Louisville and Jefferson County Metropolitan Sewer District  
700 West Liberty Street  
Louisville Kentucky 40203-1911  
502-540-6000  
[www.msdlouky.org](http://www.msdlouky.org)

August 17, 2012 (Revised September 20, 2012)

Subject: I-64 and Grinstead Drive Storage Basin  
Minor Project Modification  
IOAP Project No. L\_MI\_MF\_127\_M\_09B\_B\_A\_8  
DOJ Case No. 90-5-1-1-08254

Middle Fork Beargrass Creek  
SolutionID # L\_MI\_MF\_127\_M\_09B\_B\_A\_8  
I-64 and Grinstead Drive Storage Basin

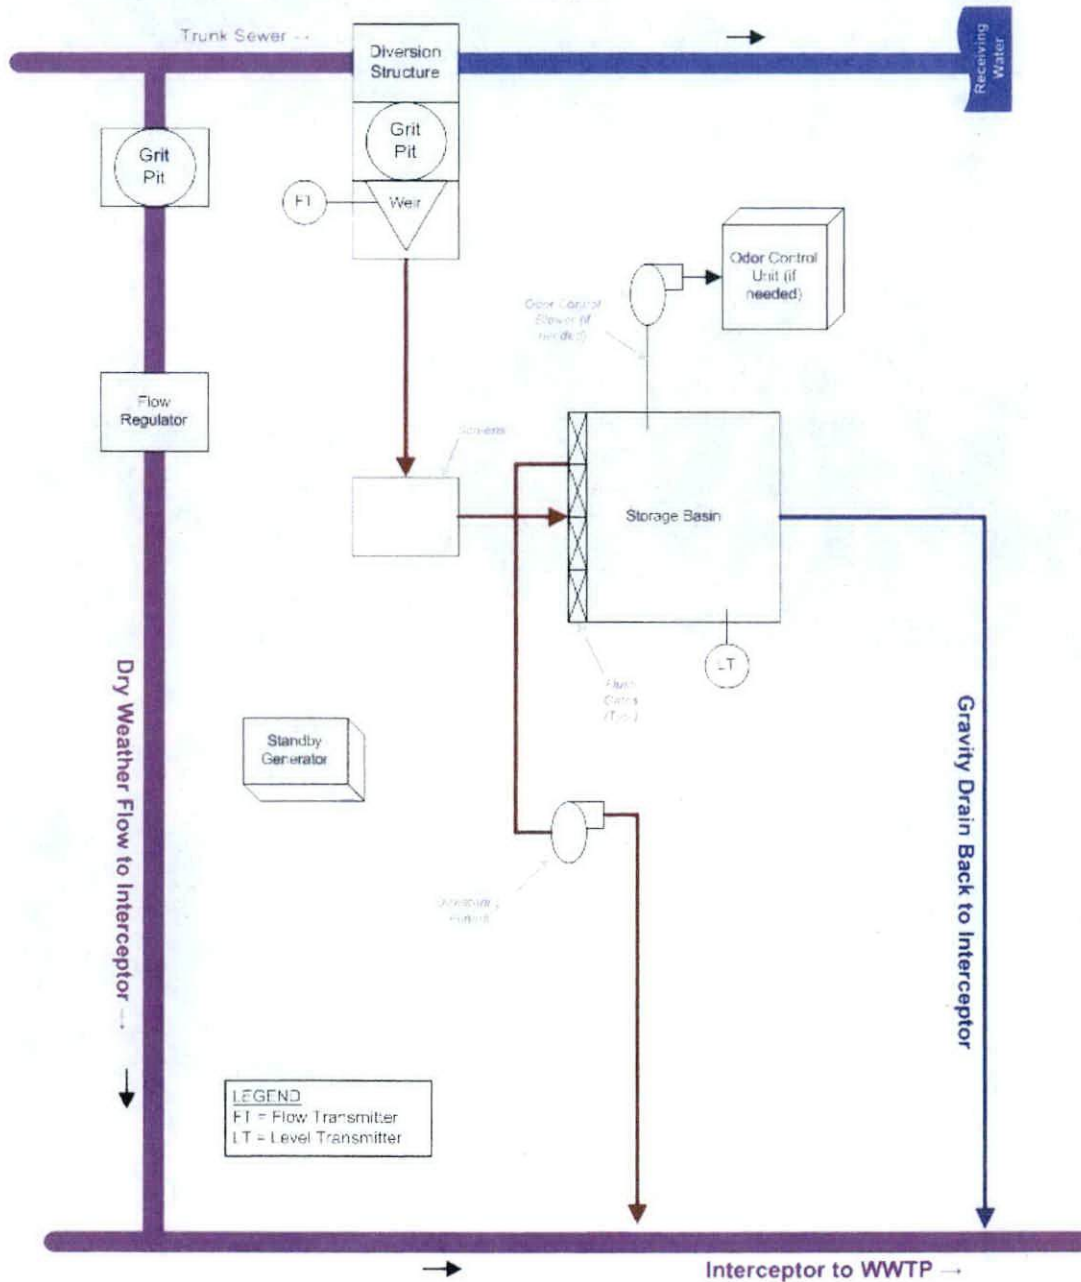
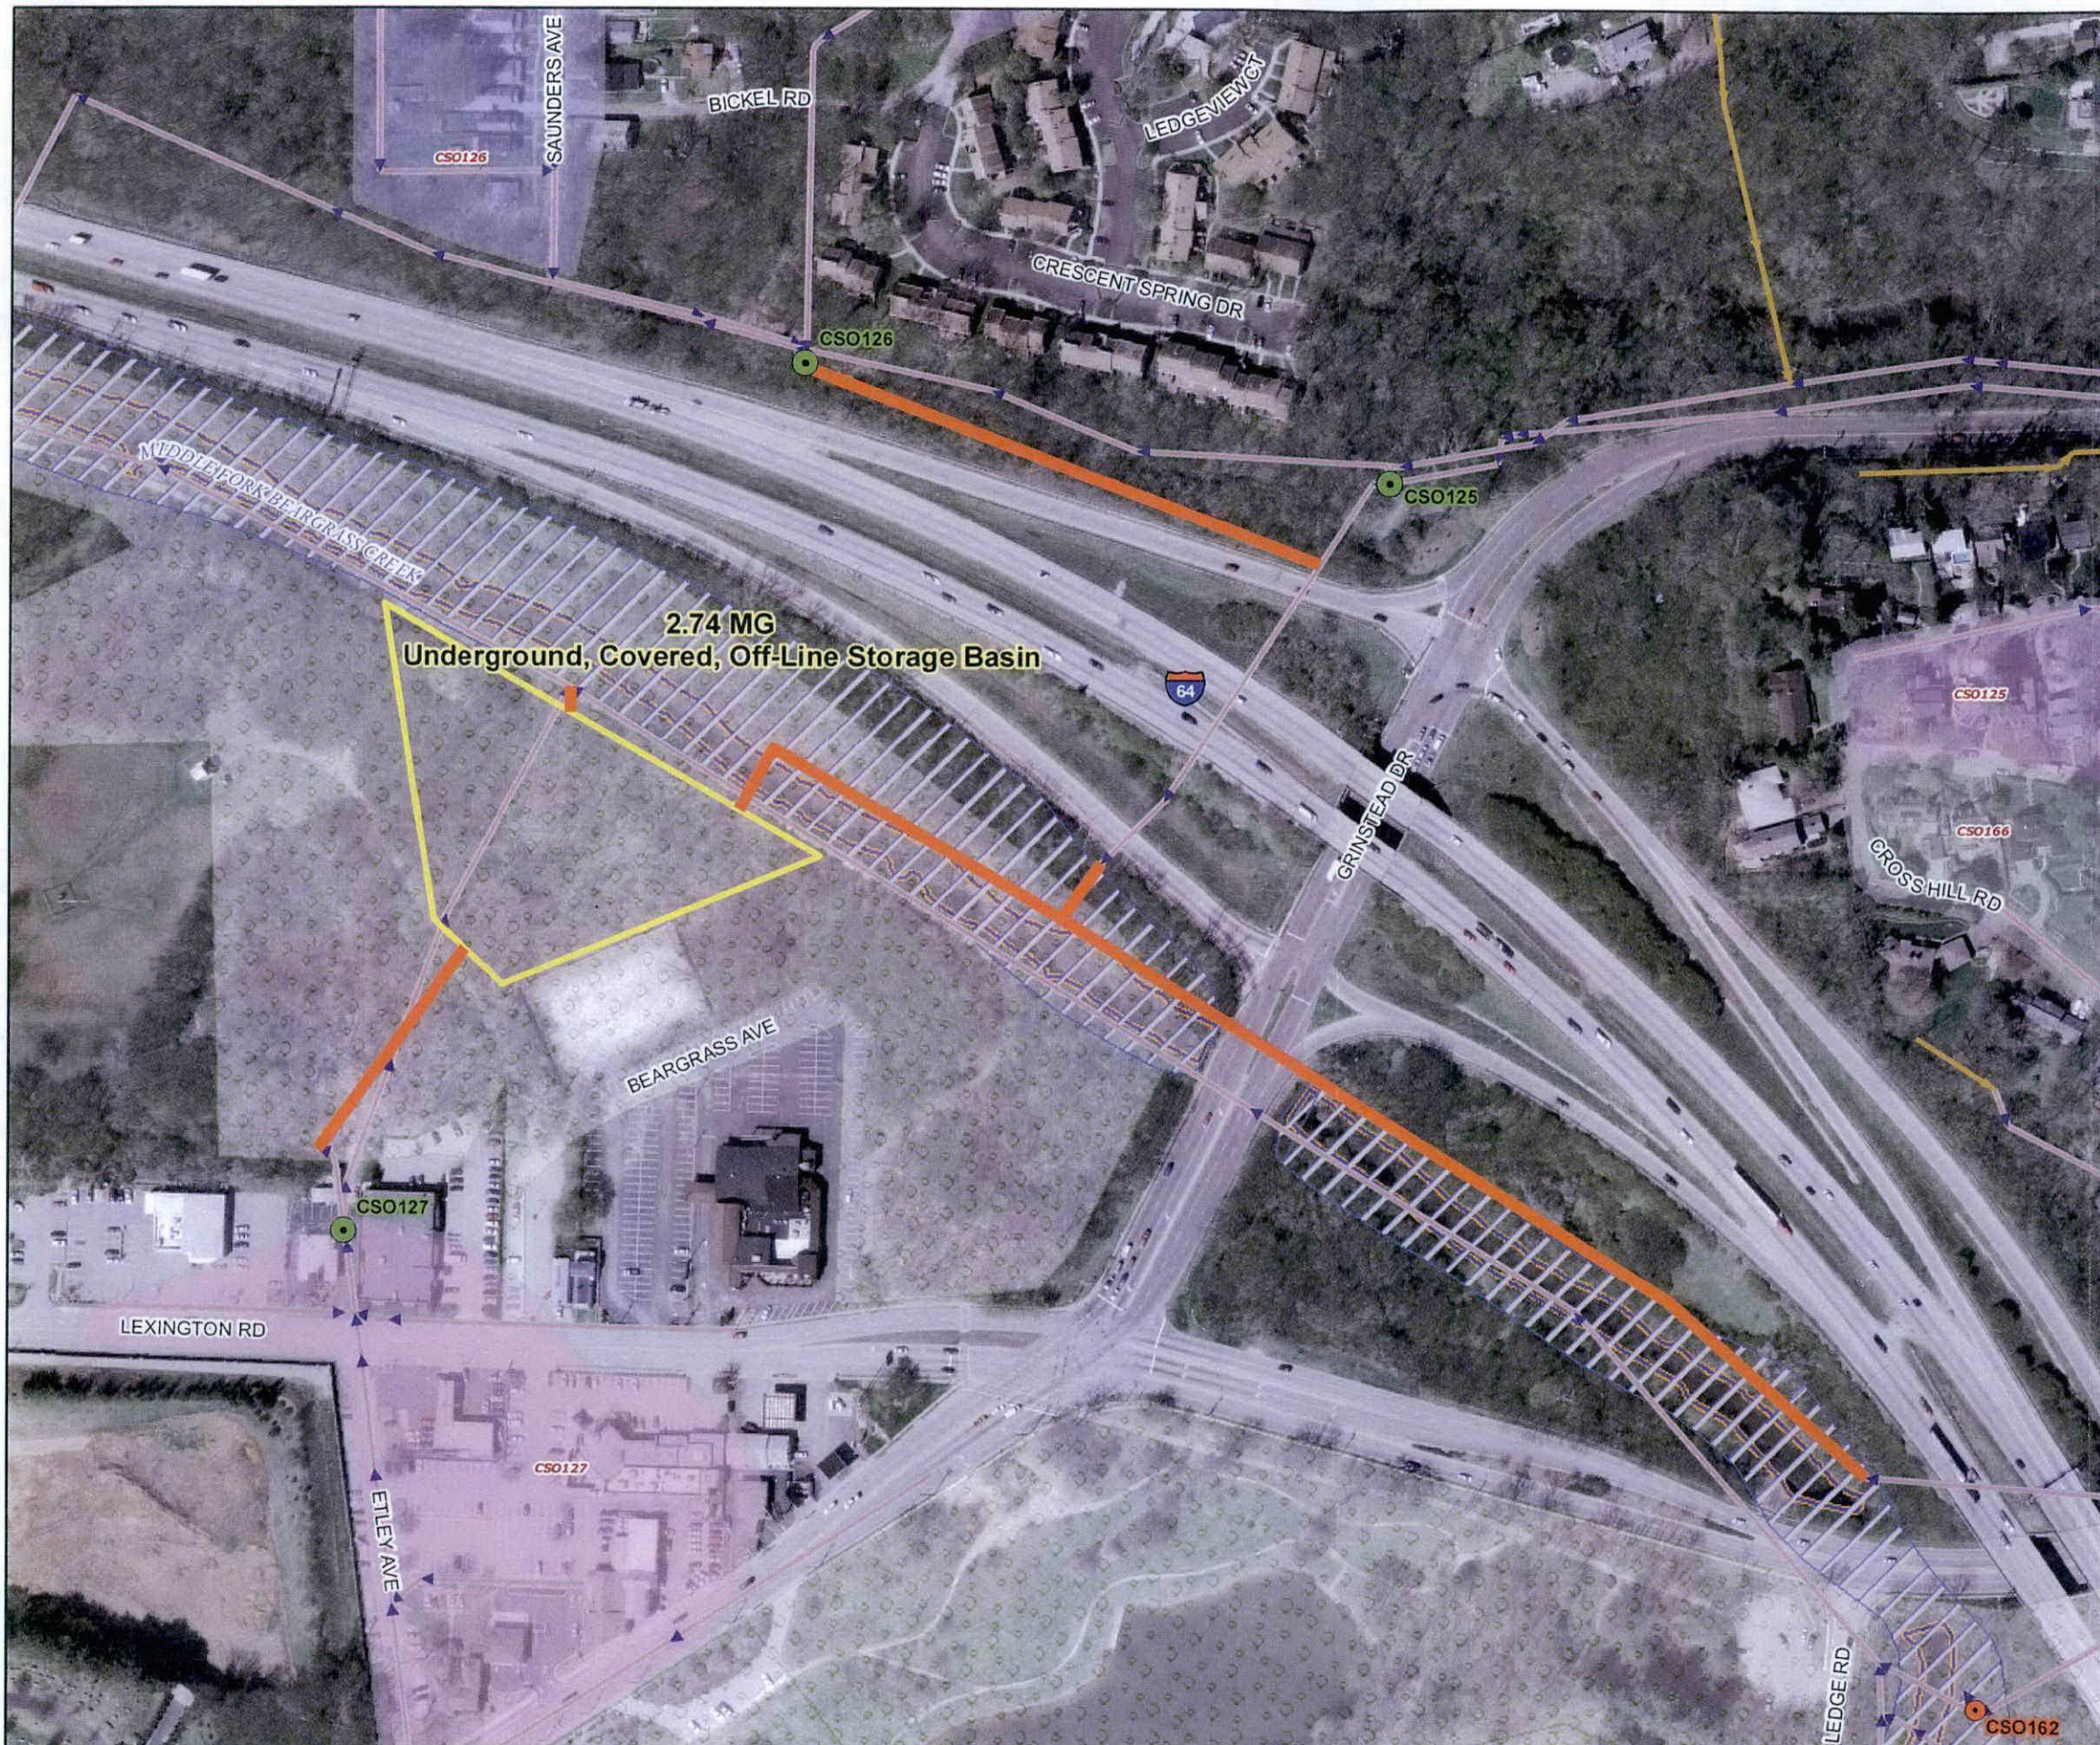
The original I-64 & Grinstead Drive Basin project involved the construction of a 2.74 million gallon (MG) storage basin to be completed by December 31, 2014, with an eight overflows per typical year level of control.

The project modification involves the construction of a 15.33 MG storage basin to be completed by December 31, 2020, with a four overflows per typical year level of control. Moving the schedule into 2020 will allow for the proper construction of such a large basin and the incorporation of the green infrastructure within the drainage area of the four combined sewer overflows controlled by the basin. MSD is analyzing potential green infrastructure projects to possibly reduce the size of the storage basin.

Based on the results of the re-calibration, a level of control analysis was conducted on the I-64 and Grinstead Storage Basin. The level of control analysis showed that the basin size of 15.33 MG would meet a level of control of four overflows per year and provide the highest benefit/cost ratio. Therefore, MSD proposes to change the I-64 and Grinstead Drive Storage Basin solution from a 2.74 MG basin to a 15.33 MG basin.

Additionally, the public has requested that the use of green infrastructure strongly be considered in this area in conjunction with gray infrastructure. Based on this request, MSD is also proposing to evaluate green infrastructure to determine if its use in some areas is cost effective to reduce the basin size. Based on the large drainage area, the large basin size, and the resulting high quantity of stormwater reduction required, significant public and private participating will be necessary to evaluate the potential impacts. Therefore, based on the increased basin size and the desire to further evaluate and implement potential green infrastructure opportunities, MSD is requesting to change the project completion date from December 31, 2014, to December 31, 2020.

**Project Description:** This project is to provide a 15.13 MG off-line storage facility consisting of a covered concrete basin for CSO125, 126, 127 & 166 to reduced overflows to 4 overflows per typical year. The facility will be a gravity in-pump out operation.

**Design Assumption:** No backflow from Beargrass Creek is accounted for in model. Flapgates may need to be analyzed. Direct runoff from I-64 into outfall pipes is currently included in basin size. Separation may reduce basin size if cost effective. CSO 126 likely will be conveyed directly under I-64.
